Rosemont Mine Supplemental Information (Draft of March 01, 2015) Report Review Bureau of Land Management Comments

The Bureau of Land Management (BLM) is charged with the protection and conservation, in perpetuity, of the significant resources located within the Las Cienegas National Conservation Area (LCNCA). We appreciate the effort the US Forest Service, Coronado National Forest has taken to analyze the impacts of the proposed Rosemont Copper mine project through its Final Environmental Impact Statement (FEIS) and draft Supplemental Information Report (SIR). As a cooperating agency, we look forward to continuing work together throughout this evaluation process.

Example of this process from the Charleston stream gauge on the San Pedro River -

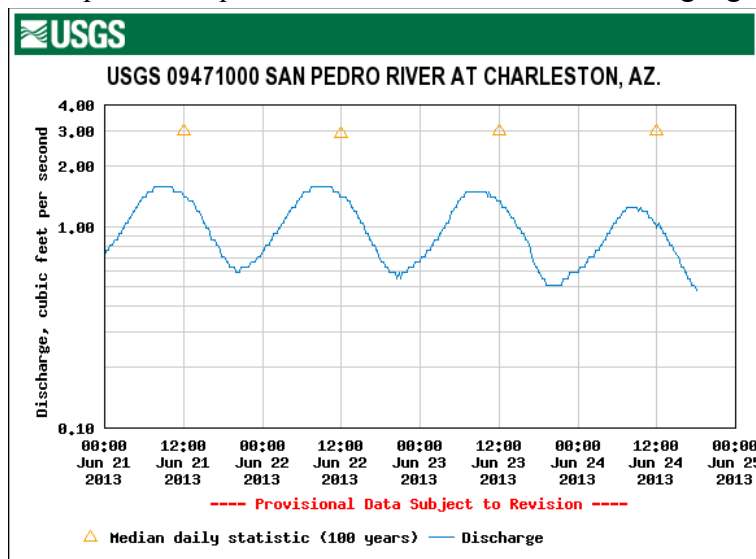
The SIR attempts to provide close approximations of effects to aquatic habitat and riparian function from small increments of drawdown using data collected during a wet winter when stream discharges are greatest and effects from a complex set of environmental conditions are not apparent. In June and July, groundwater elevation are reduced, but other factors are also at play including diurnal swings in groundwater elevation from the effects of evapotranspiration that cause pool depths and surface water extent to rise and fall daily. Measurements of pool

depths in the morning will be much greater in the morning than afternoon when they may actually be dry.
